1 LIGHTING AND POWER PLAN
E101 SCALE: 1/8"=1'-0"

Project Title: WALGREENS SALES AREA LED LIGHTING UPGRADE

WALGREENS STORE - LIGHTING UPGRADE

City of Aurora Building Division
Reviewed for Code Compliance
Approved as Noted: **sgolfobi**
Date: **Dec 16, 2025**
2021 INTERNATIONAL CODES & 2023 NEC

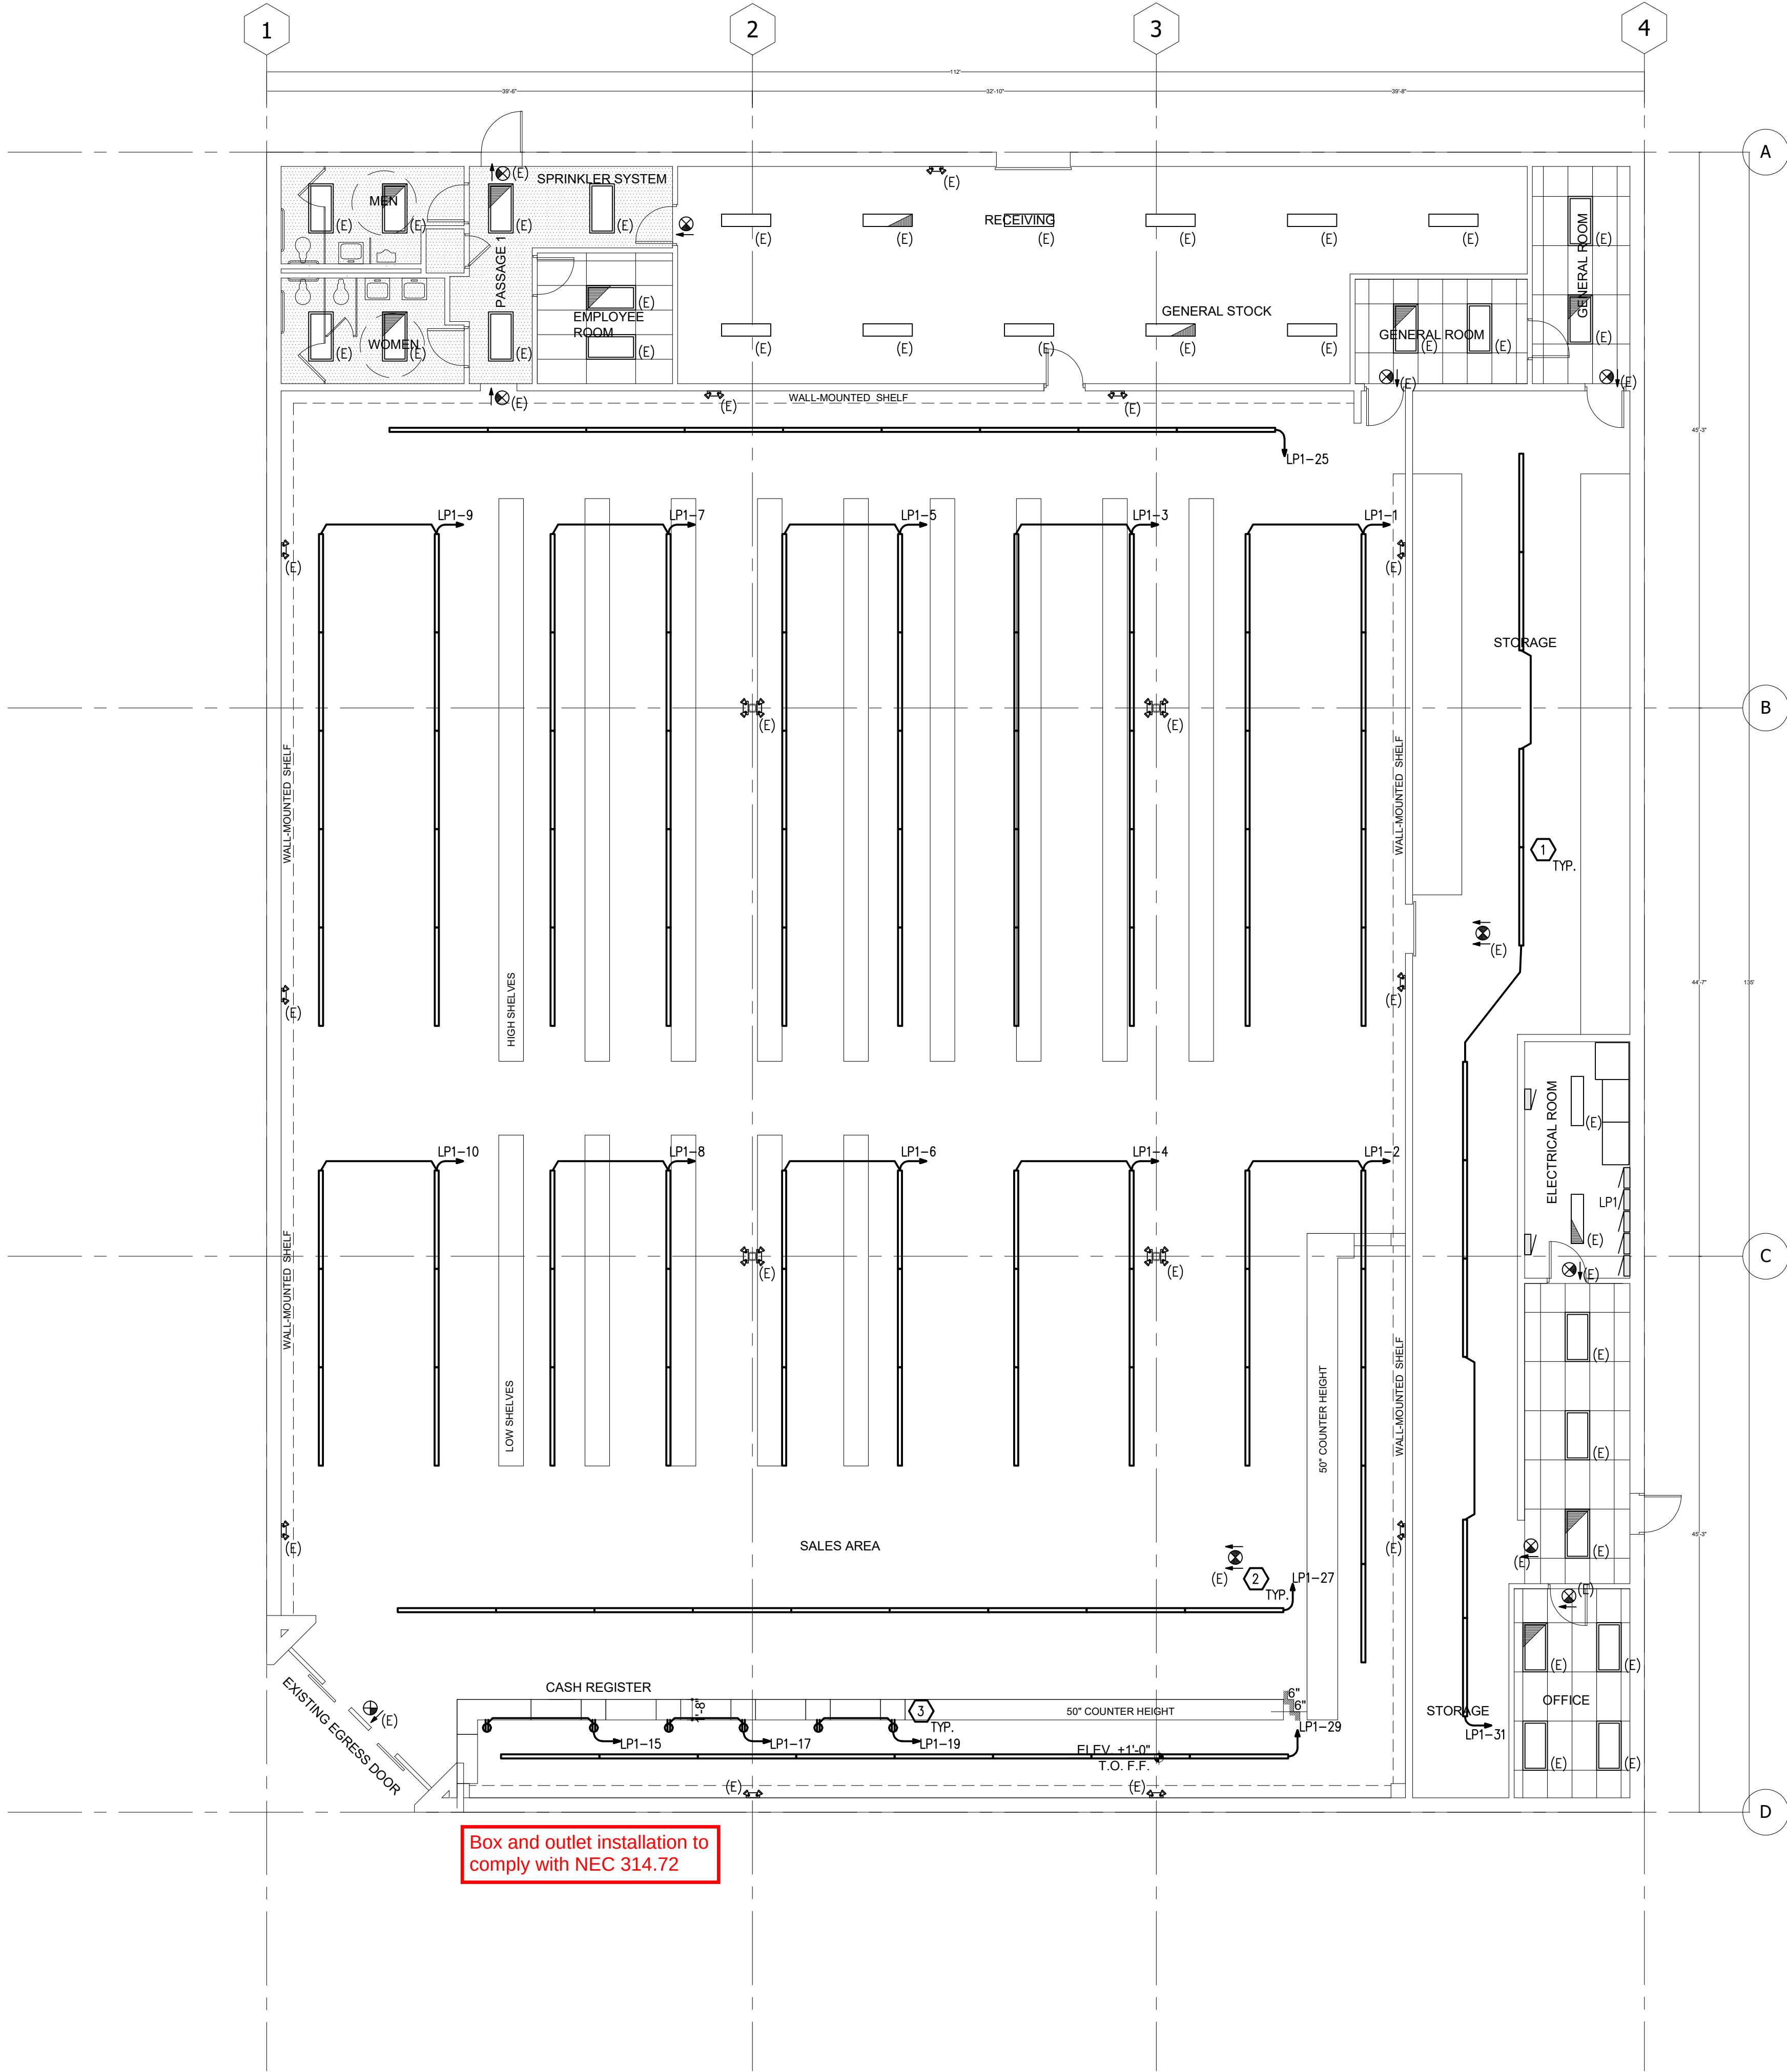
Luminaire installation to comply with NEC 410.8

Code violations found during inspections are required to be corrected. Permit issuance does not grant approval of a code violation.

Every circuit and circuit modification shall be provided with a legible and permanent description that complies with all of the following conditions as applicable (see 1-6). 2023 NEC 408.4

Box and outlet installation to comply with NEC 314.72
